31/07-04H 10210 Menlo Ave
Capitol View Historic District

1 THE MARYLAND-NATIONAL CAPITAL PARK AND PLANNING COMMISSION
2 HISTORIC PRESERVATION COMMISSION

- 3 - - - - - X
- 4 HISTORIC AREA WORK PERMIT - : HPC Case No. 23/57-05A
4501 Olney Laytonsville Road :
5 :
6 - - - - - X
- 6 HISTORIC AREA WORK PERMIT - : HPC Case No. 31/07-04H
7 ~~10220~~ Menlo Avenue :
8 **10219** :
9 - - - - - X
- 9 HISTORIC AREA WORK PERMIT - : HPC Case No. 31/06-05D
3920 Baltimore Street :
10 :
11 - - - - - X
- 11 PRELIMINARY CONSULTATION - : Clarksburg Historic
12 23310 Frederick Road : District
13 :
14 - - - - - X

FRONT ELEVATION

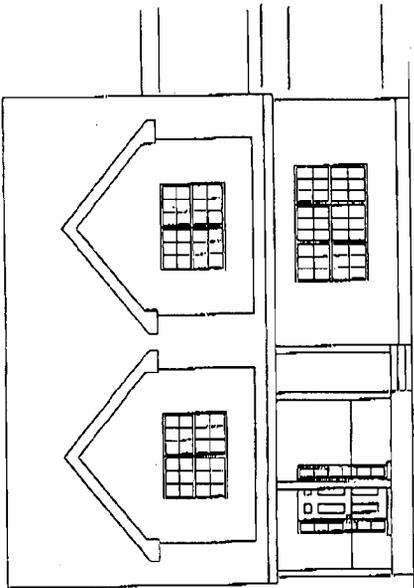
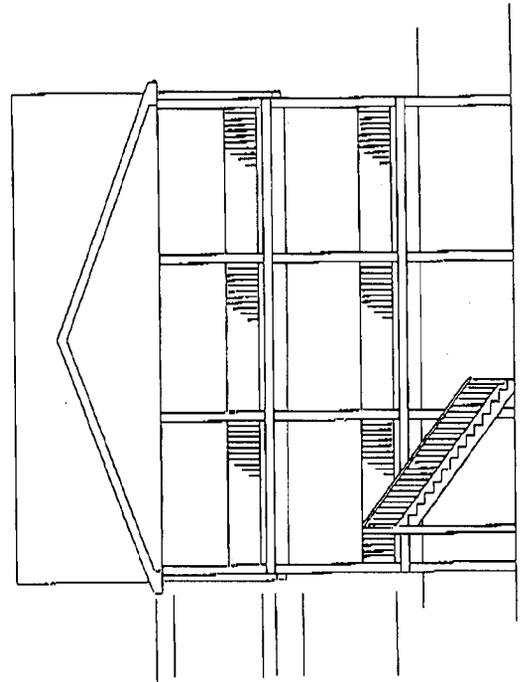
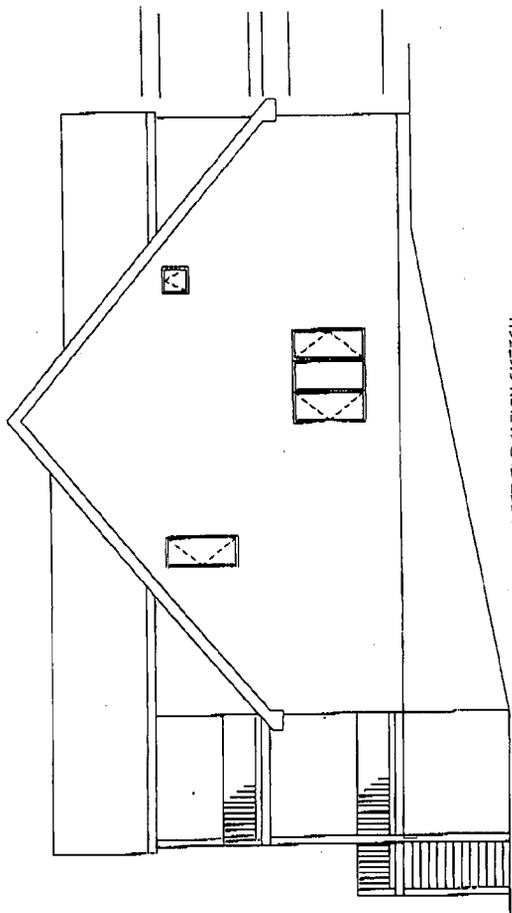
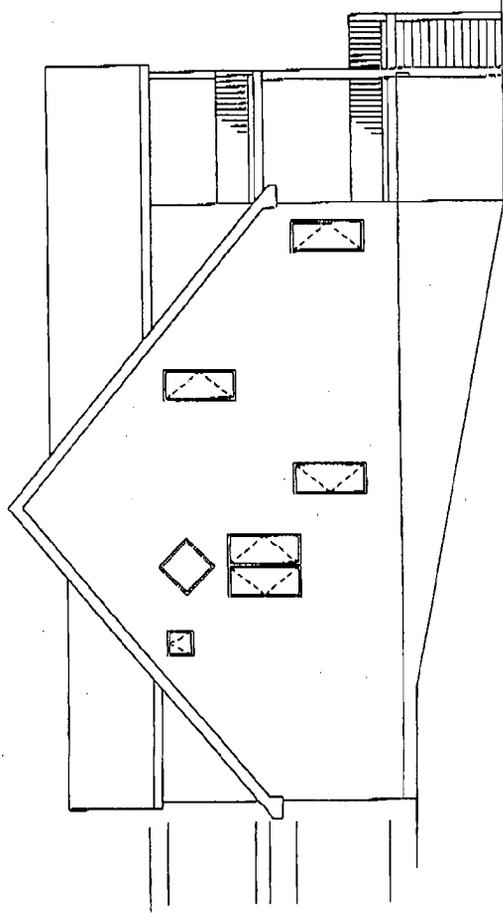
The new drawings as faxed seem to address most of the comments made by the Commission. I will provide comments on the new design at the time of submittal unless requested before then.

ELEVATIONS

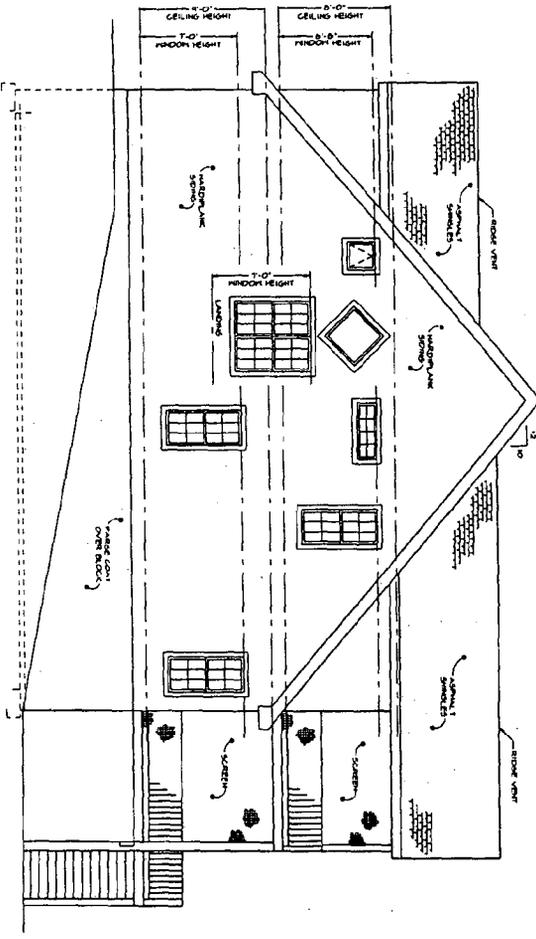
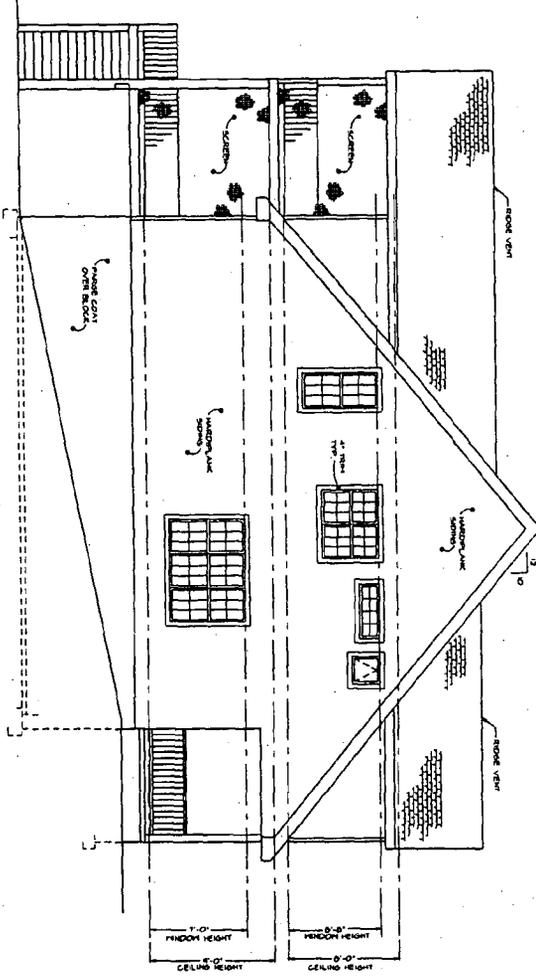
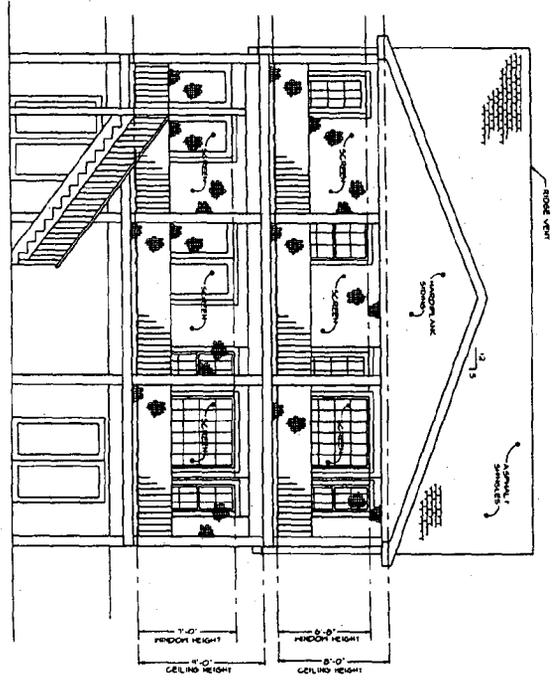
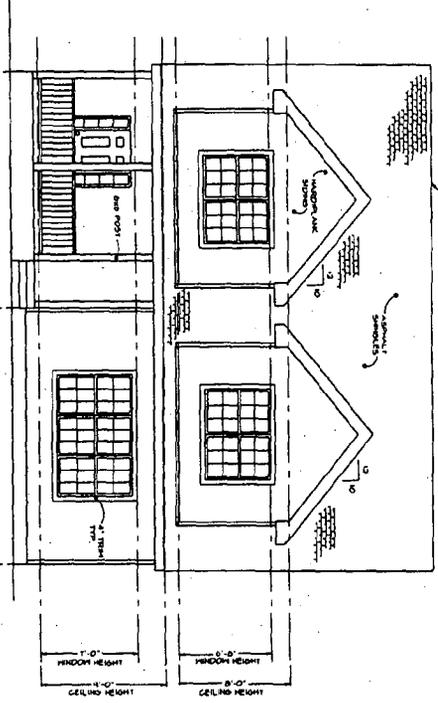
13 As it relates to this house, I guess my concerns
14 on it; number one if you look at the front elevation, the
15 size of the central section looks too insignificant in
16 relationship to the rest of the house. It's sort of a small
17 added on element.

1 MR. FULLER: Circle 10. I don't know that it has
2 to be anywhere near as detailed as what Staff had put forth
3 as potentially another alternative, but I do think it needs
4 to be broken down in scale somehow. It needs some other --
5 it needs some other elements added to it.
